Economic Commission for Europe**Inland Transport Committee****World Forum for Harmonization of Vehicle Regulations****Working Party on Lighting and Light-Signalling****Seventy-second session**

1958 Agreement - Regulations**Other business – Any other business****Proposal for a Supplement to the 01 series of amendments to Regulation No. 112 (Headlamps emitting an asymmetrical passing-beam)****Submitted by the expert from France***

Figure 1. Light distribution

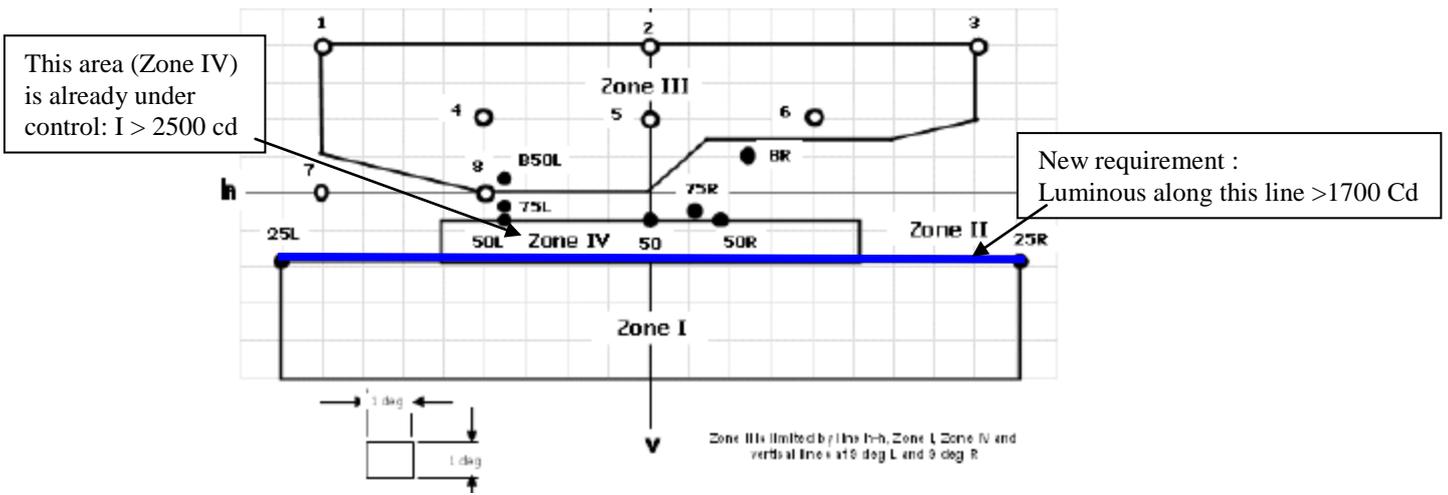
5. During examination of informal document GRE-71-09, some experts mentioned that the reduction of flux of the LED light source may have an influence on the light distribution of the beam pattern. Such concern may also be applicable to other types of light sources. Consequently, the proposal was amended so as to check that the illumination along the line 25L -25R is above a lower limit.

"6.2.9. Along the horizontal line between 25L and 25R, the luminous intensity shall not be less than 1,700 Cd;

Figure 2. Luminous flux in the field: 265 Lm.

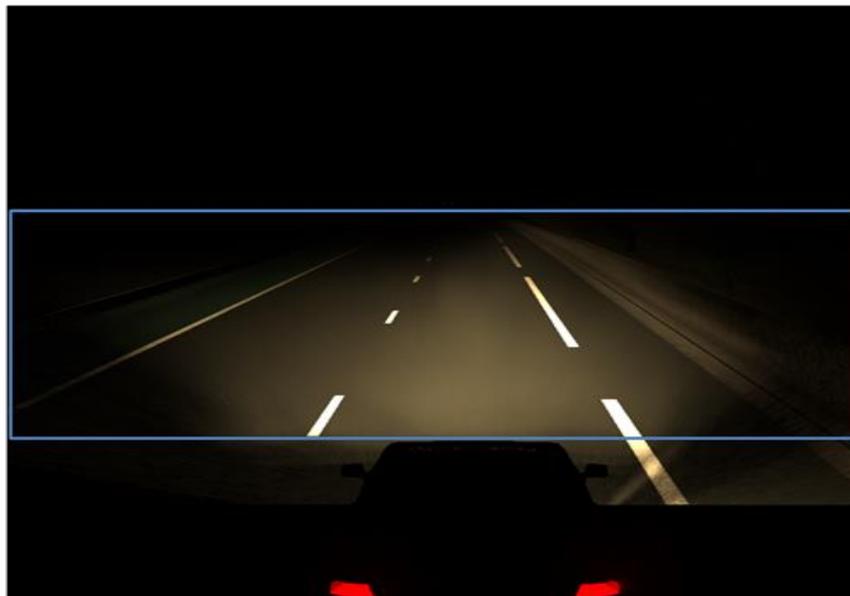
6. Additionally, to ensure a safe luminous output, a new request is added for a minimum luminous flux of the headlamp in the forward field (see picture hereunder).

The luminous flux in the rectangular forward field: horizontally (30°L 30°R) – vertically (10°D - 0°) shall be not less than 250 Lm."
